MEMORANDUM

March 22, 2019

SUBJECT: Veirs Mill Corridor Master Plan—fiscal impact statement, evaluation of transportation adequacy at buildout; transportation elements

Figure 1: Severe and Fatal Crashes on and Near Veirs Mill Road (2015-2017)

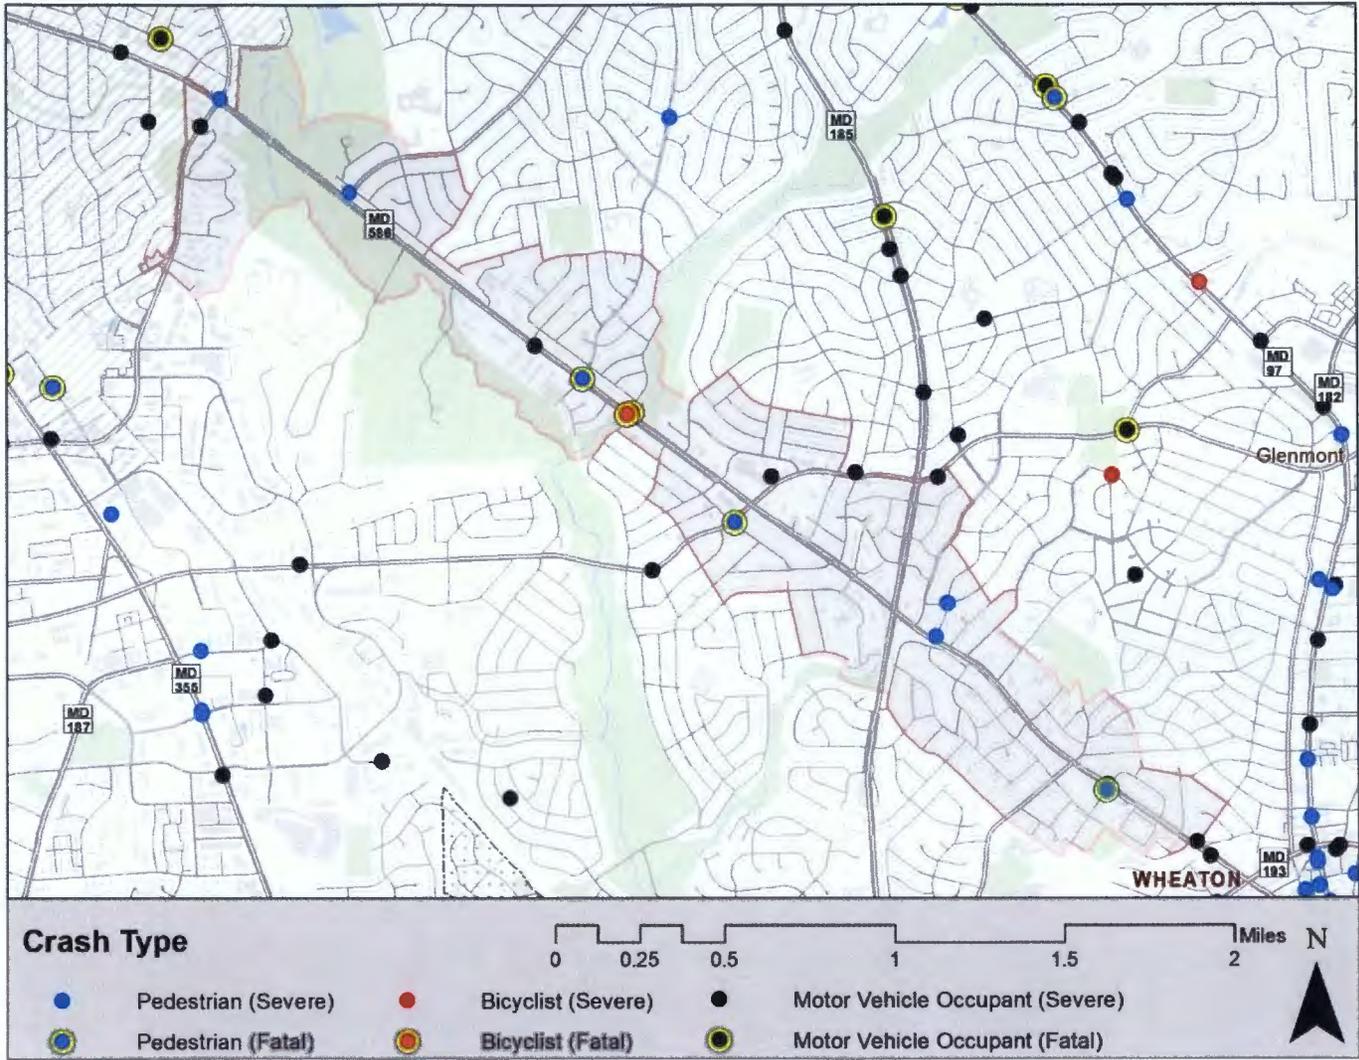
The safety experience on the two highways also differs. A map in a Draft Plan appendix (©14) shows that between 2015 and 2017 there were 3 fatal and 7 severe-injury crashes on Veirs Mill Road from just north of the Wheaton CBD to the Rockville boundary. Two of the fatal crashes were due to the unique circumstance of the at-grade crossing for the regional Matthew Henson Trail. The same map shows that on Georgia Avenue from just north of the Wheaton CBD to the Matthew Henson Trail crossing of Georgia Avenue—nearly the same distance—there were 2 fatal and 16 severe-injury crashes, nearly twice as many serious accidents than on Veirs Mill Road during the same period.
